Service Information

Category P	Modification	Ref. No. M001/13	Page 1 of 2
Coverage <input type="checkbox"/> Distributor only <input checked="" type="checkbox"/> Please inform your dealers		Date Issued January 25, 2013	
Please convey this information to your <input type="checkbox"/> Director <input checked="" type="checkbox"/> General Manager <input checked="" type="checkbox"/> Warranty Dept. <input checked="" type="checkbox"/> Parts Dept. <input checked="" type="checkbox"/> Training Dept. <input checked="" type="checkbox"/> Field Rep.		Date Revised	
Applicable Model CX-7, CX-9, MX-5, Mazda8(MC Product)		Applicable Countries or Specifications Worldwide

Subject: Discontinuation of fixing screw for front disc plate

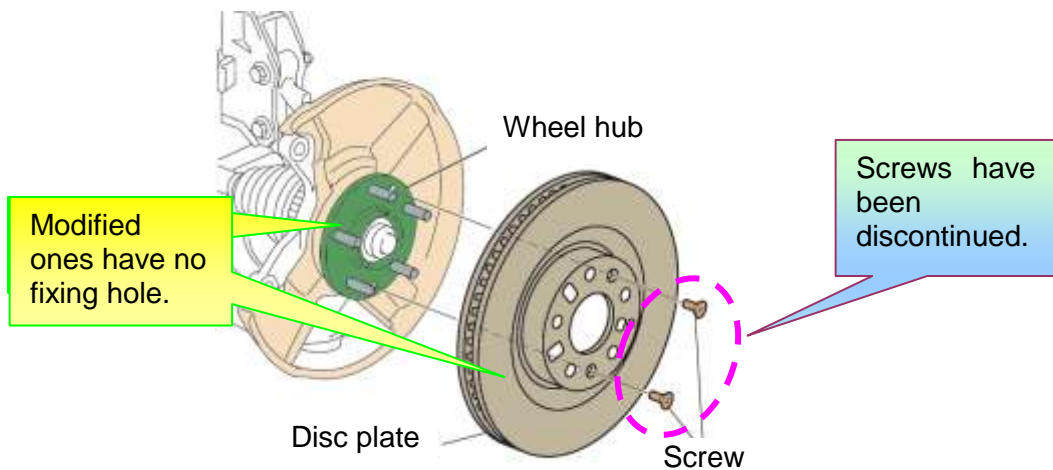
The screws to fix the disc plate on the wheel hub have been discontinued.
With this change, the wheel hub and disc plate have also been modified to without fixing hole.

On vehicles after modification the hole on the disc plate and wheel hub is omitted. It is not necessary to use the screws accordingly.

When you install the modified disc plate or wheel hub without fixing hole on the vehicle before the modification, you do not need to install the screws. Install the disc plate on the wheel hub, install the tires and tighten them all together with wheel nuts. You can discard the screws.

There is no problem even if screw is installed only on one side.
